CITY OF LA CAÑADA FLINTRIDGE

PLANNING COMMISSION STAFF REPORT

June 14, 2016 Meeting

4377 Chevy Chase Drive

As submitted (above); modified by staff (below)

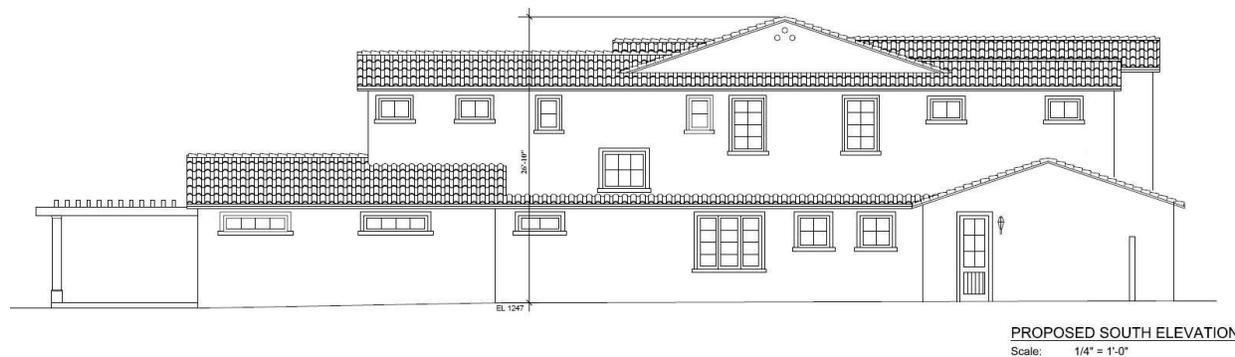
Lastly, staff has a minor comment on the south window array, which seems excessive along the front half, where four full-size windows are proposed, two bedroom and two activity room windows (*the 2nd-floor plan shows a third activity room window, which staff assumes is erroneous*). Compared with the use of much smaller windows to the rear, albeit two of which are closet windows, a lopsided effect results, imparting the impression of a disjointed 2nd floor. Additionally, the forward-most window appears crowded by the garage ridge. Relief is achievable through conversion of the activity room windows from full-size windows to transom windows. This would visually correlate the ends of the south elevation and improve its overall appearance in staff's estimation. Importantly, the lighting effect from conversion to transom windows would be adequately offset by the glass terrace doors and windows proposed along the east side of the activity room. A condition requiring this change is not included at this point; rather, staff offers it for consideration. Comparison shown on next page.
